The CSR-DHOT required the end bracket arm length in SECTION 4.3/3.2.3 Bracketed connections. This arm length includes the height of the attached stiffener and the height of the bracket. ($l_{bkt} = h_{stf} + \text{the height of the bracket}$)

Figure 4.3.1
Bracket Arm Length

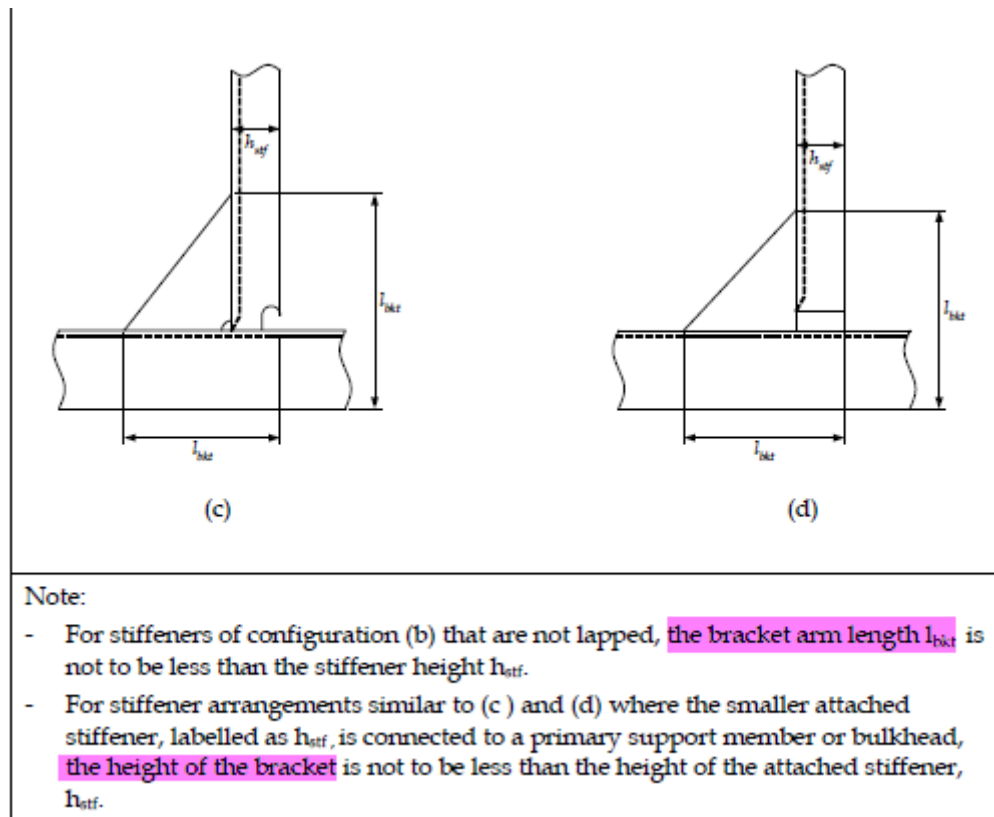
But according to SECTION 4.3/3.3.3 Brackets

3.3.3.1 In general, the arm lengths of brackets connecting primary support members are not to be less than the web depth of the member, and need not be taken as greater than 1.5 times the web depth. The thickness of the bracket is, in general, not to be less than that of the girder web plate.

the arm lengths of brackets mentioned above is obviously equal to the height of the bracket. ($l_{bkt} = \text{the height of the bracket}$)

So I suggested clear clauses to be issued.
